EAGLE MOUNTAIN PLANNING COMMISSION MEETING

July 27, 2021, 5:30 PM

6.B PUBLIC HEARING - Stonebridge Montessori

**EAGLE MOUNTAIN CITY
PLANNING COMMISSION MEETING
JULY 27, 2021**

Scale: 1"=20'
Date: 07/16/2021
Sheet: C3

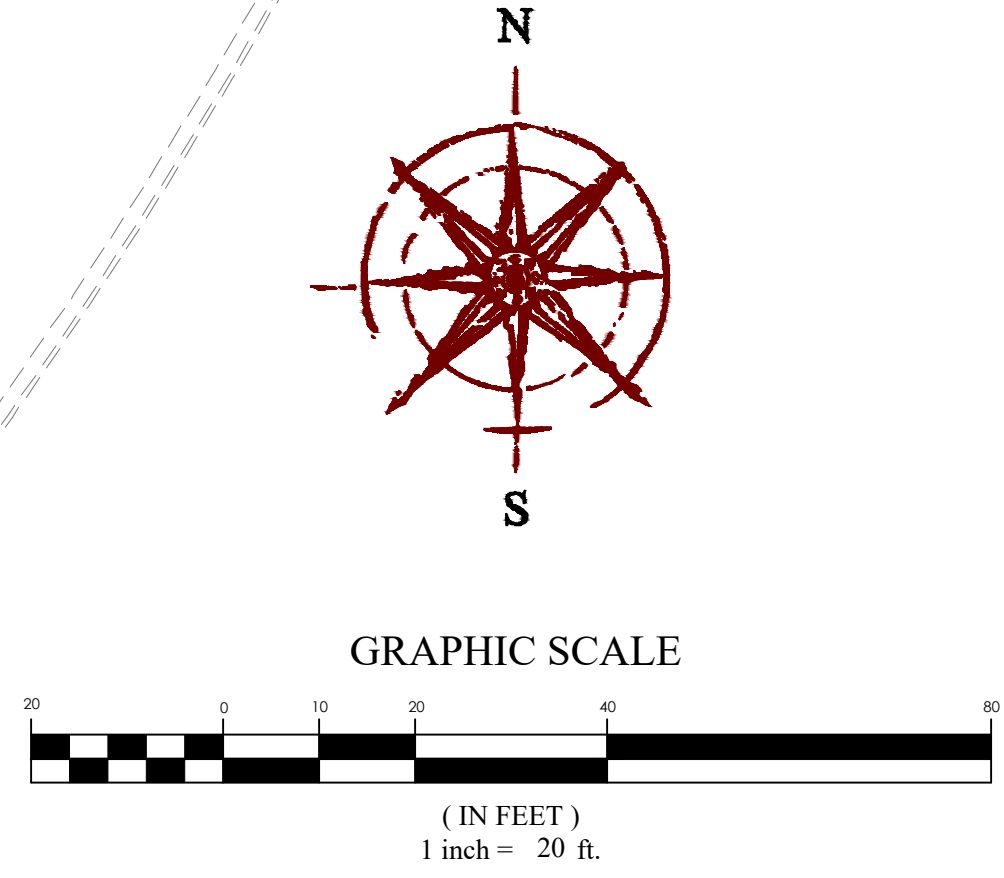
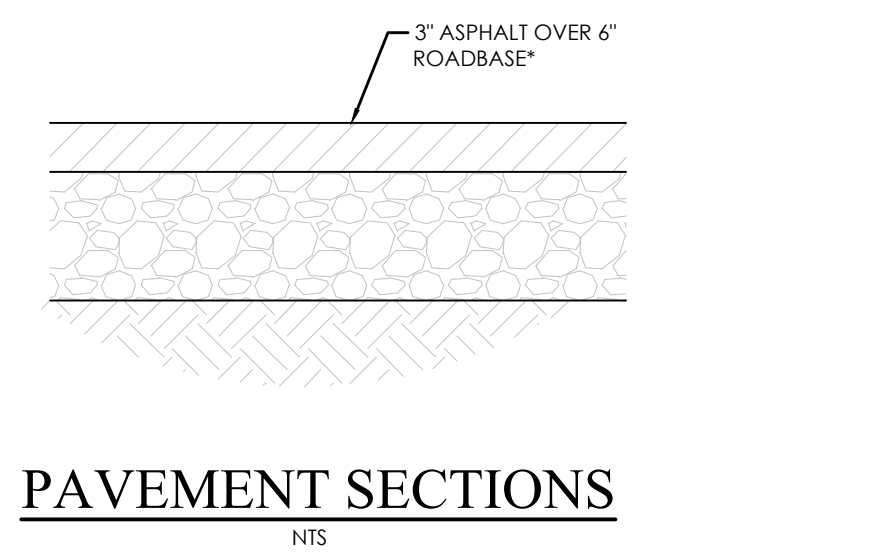
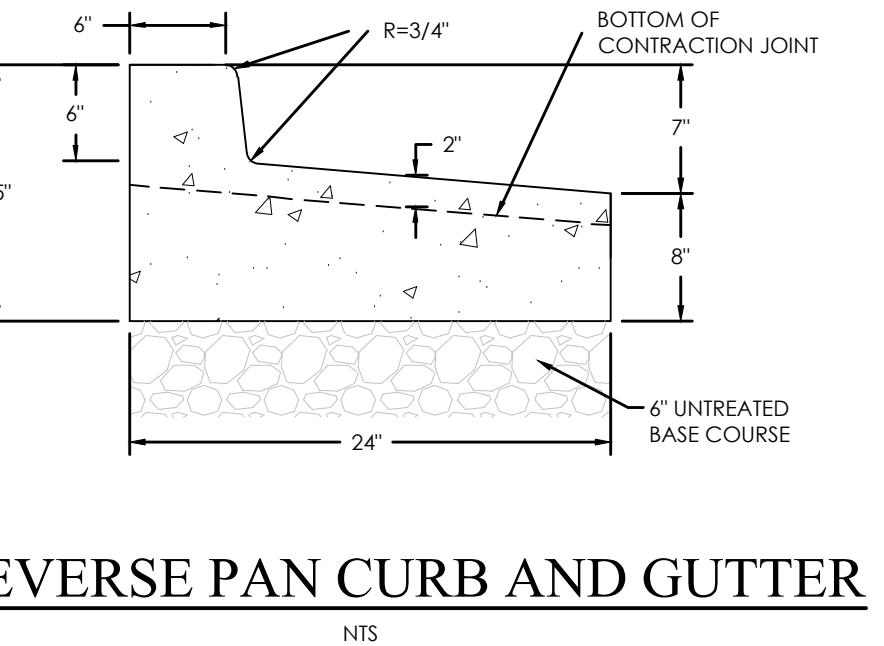
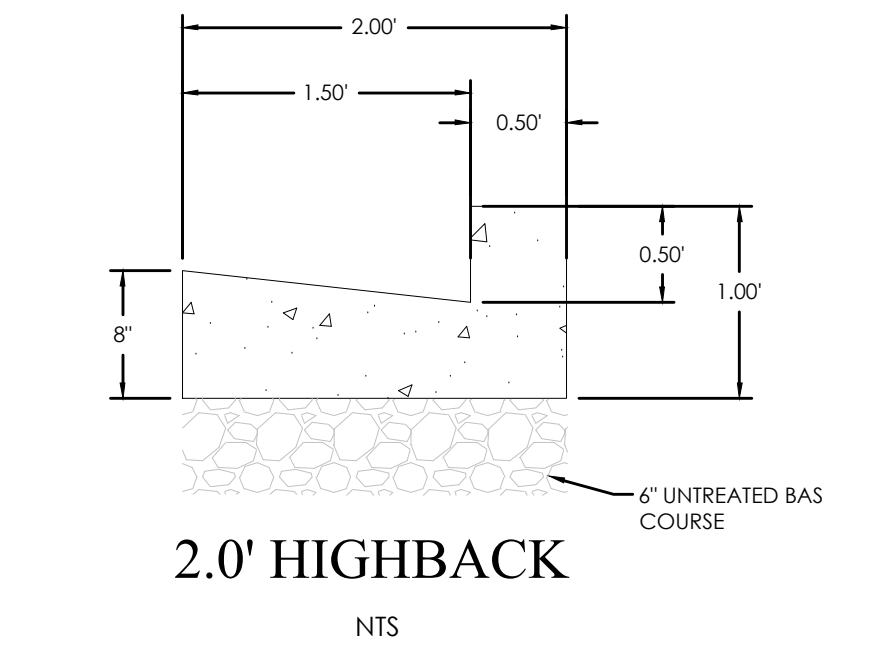
stall per staff member plus 1 stall per 10 children. The site plan shows 32 spaces, including two ADA spaces, which does comply with this code.

Per EMMC 17.75.052 (A2) "Adequate off-street stacking areas which are completely contained on site for student pickup and drop-off are required. No off-site stacking is permitted." The site plan does show a student pickup and drop-off area in front of the school. The code is not specific about what length the parking stacking should be, the applicant shall provide proof that stacking distances are adequate and will not cause traffic to back onto public ROW's.

Per EMMC 17.75.052 (B2) "Primary pedestrian crossing shall employ traffic calming features such as speed tables and striping. Secondary pedestrian crossings shall employ a minimum of striping and signs." The site plan shows striping from the ADA parking area to the front entrance of the school, the Planning Commission shall determine if that provides sufficient traffic calming.

The school will be accessed from E. Stonebridge Lane. Staff has recommended to previous applicants interested in this lot that they collaborate with the property owner to the west to create an access road along the west property line to benefit both properties and run to the north which would provide access to this property's parking lot. In an effort to work with staff and consider previous comments from development reviews, the applicant has submitted a site plan to show a drive aisle connecting the surrounding properties; although, they would prefer not to include the drive aisle design as they feel it poses increased safety hazards for students attending the school. Staff agrees that it is not desirable to have commercial access coming through a school parking lot and feels it is appropriate to not require cross access between parking lots in this location.

Per EMMC 17.72.030 (B) "Locate surface parking to the side or the rear of buildings. Parking should not be located between any commercial building and the street." The sit plan shows parking at the southern portion of the parcel between the street and building. Staff has recommended that the applicant turn the building 90 degrees and locate it at the southeast corner of the lot. With the south and east faces adjacent to the two streets, the parking and play areas can be located to the west and north.

Per EMMC 17.55.040 (G) "Headlight screening is required around the perimeter of all areas adjacent to residential uses, or as deemed necessary by the planning director. A headlight screen shall consist of a berm, fence wall, or landscaping consisting of at least three and one-half feet in height and capable of blocking headlight glare." The updated landscape plans show a 10 foot landscape buffer at the south east corner of the parcel consisting of trees and shrubs. To comply with this code, a 3 and 1/2-foot high landscape buffer should be added around the perimeter of the parking area to block headlight glare.

1. The site plan be approved without a drive-aisle connecting the northern property.
2. The applicant shall provide proof that stacking distances are adequate and will not cause traffic to back onto public ROW's.
3. The applicant update the elevations to use an appropriate mixture of material that does not include stucco used on more than 50 percent of the building.
4. The building be turned 90 degrees to locate it as the southeast corner allowing parking and play areas to be located at the west and north.
5. A 3 and 1/2-foot high landscape berm be added around the perimeter of the parking area.

SOUTH ELEVATION MATERIAL DATA:
SIMULATED WOOD = 989 SF
EIFS = 1,284 SF 42%
SIDING = 401 SF
GLASS = 418 SF
TOTAL = 3,092 SF

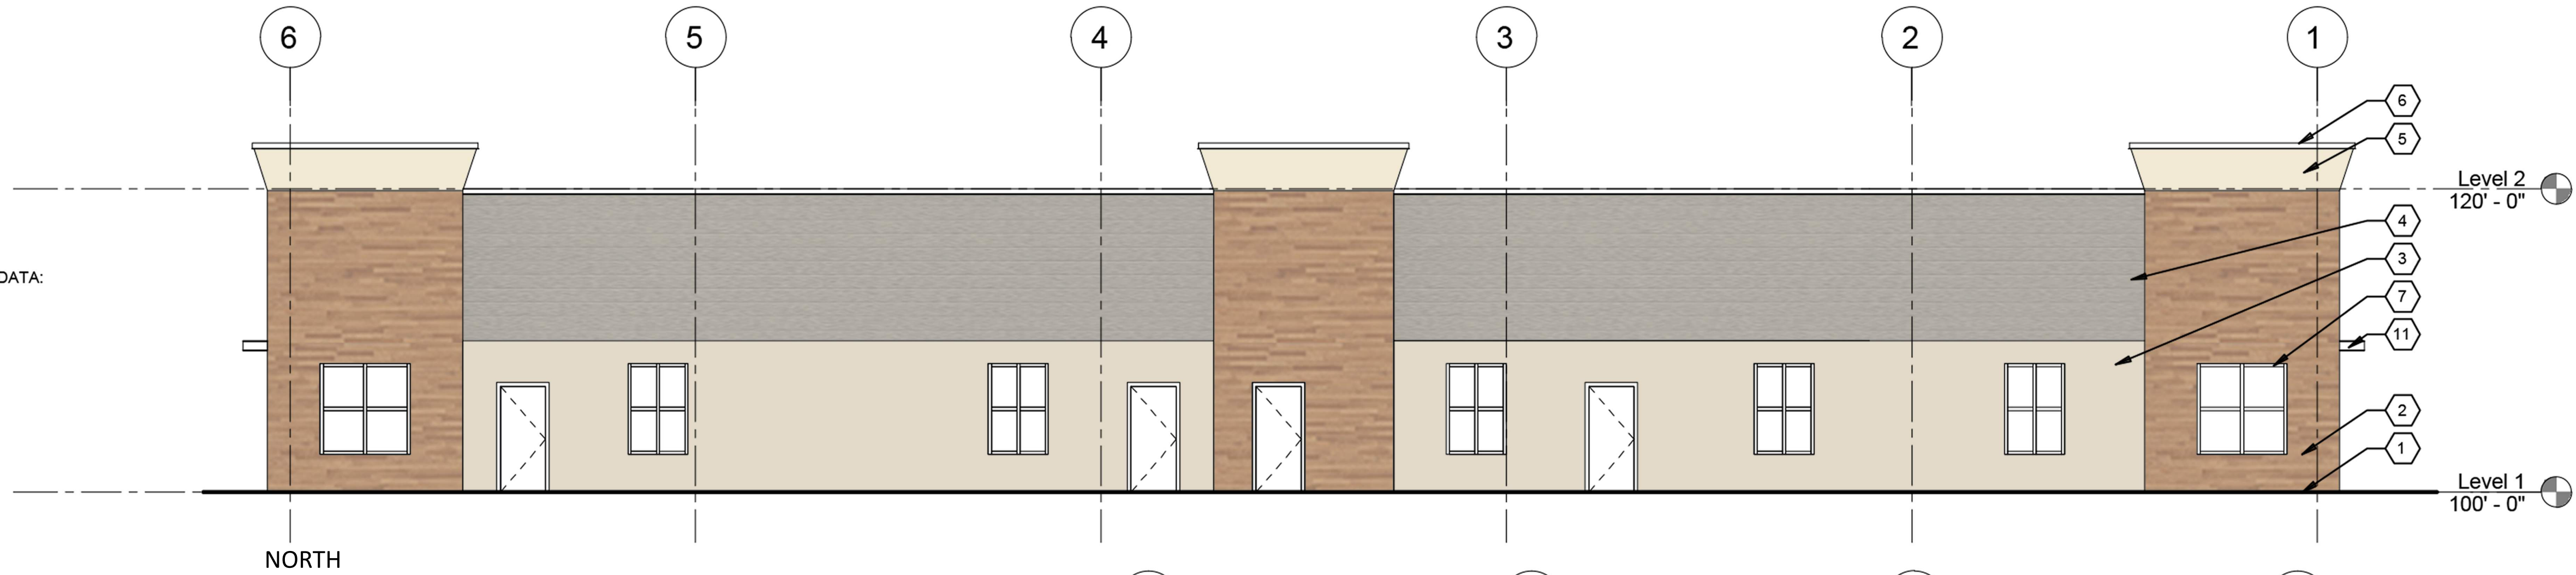
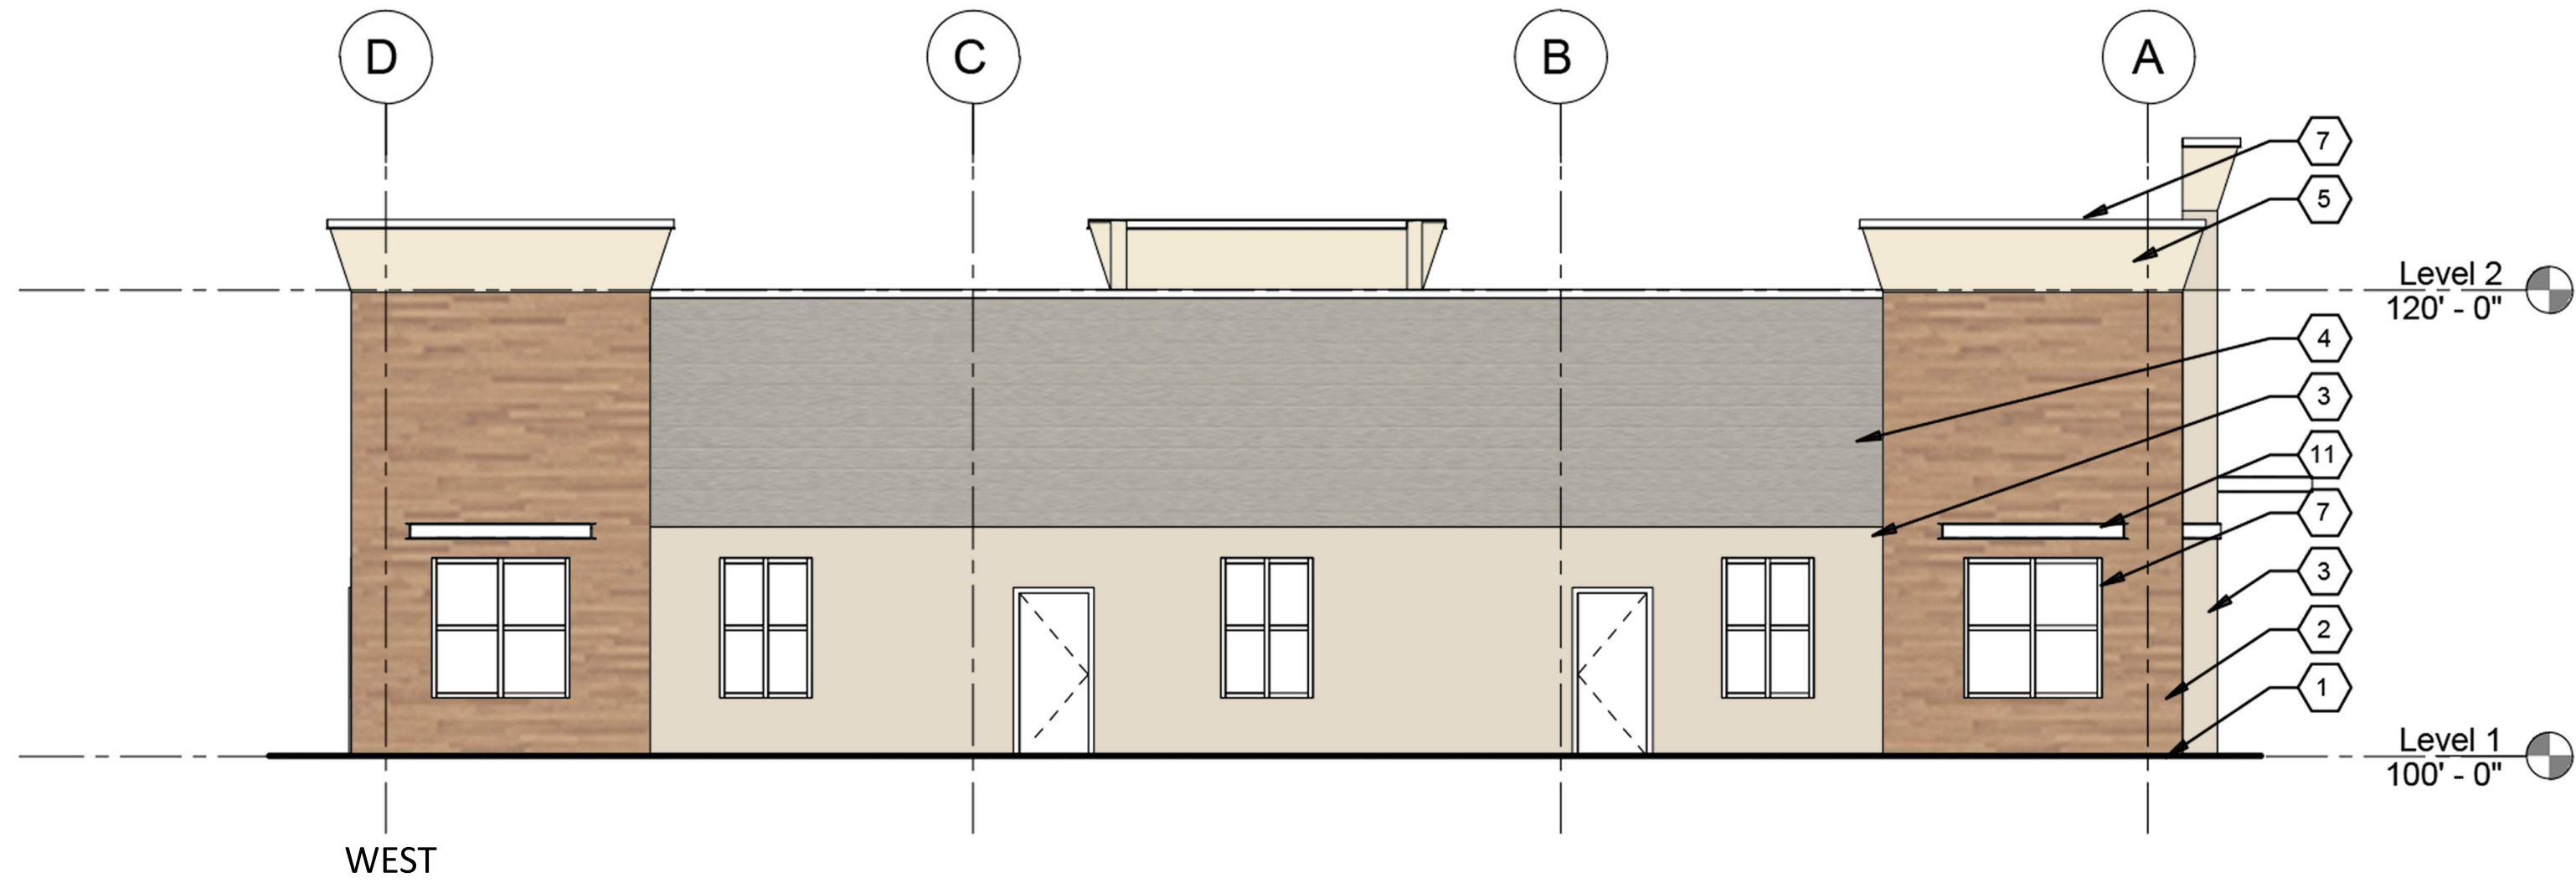
Per EMMC 17.72.040 (A) "Commercial buildings should be similar in style as significant adjacent buildings and shall be designed with consistent architectural style, detail, and trim features as the primary façade." The proposed building isn't located near any significant buildings, with the closest commercial buildings being the Maverik or the Campus Drive commercial buildings which are a significant distance away.

17.72.040 C requires that the primary roof of a structure should help reduce the scale of the building and contain decorative parapet or multiple roof planes and heights, the proposal complies with this

17.72.040 D requires vertical and horizontal articulation to reduce the perceived scale of the buildings. The building does have small popouts at the columns and uses different materials, it is up to the Planning Commission to determine if this complies with this standard.

Per EMMC 17.72.040 (F2) "All commercial buildings shall avoid large panelized products or featureless surfaces. Commercial buildings shall utilize an appropriate mixture of building materials on all sides, including brick, rock, fiber/cement siding, wood, glass, stucco, and colored architectural CMU (concrete masonry unit). Stucco may not be used on more than 50 percent of a building. Metal, plain CMU, or other materials deemed appropriate by the planning commission and city council may be used as accents only." While the applicant has since updated their elevations to improve the pedestrian-scaled architectural features/details, the plan is in compliance as stucco will be used on more than 50% of the building. Staff recommends the applicant update the elevations to come in to compliance with an appropriate mixture of materials listed in this code.

Per EMMC 17.72.030 (A1) "the primary entrance to a commercial building should be oriented toward the street and the sidewalk. Orienting the primary entrance to a parking area without addressing the street-facing façade with entrances, displaying windows, awnings, increased architectural elements, increased landscaping, and/or other pedestrian-oriented features is prohibited." During the concept plan review, staff recommended that the building be turned 90 degrees and located it at the southeast corner of the lot as the commercial code
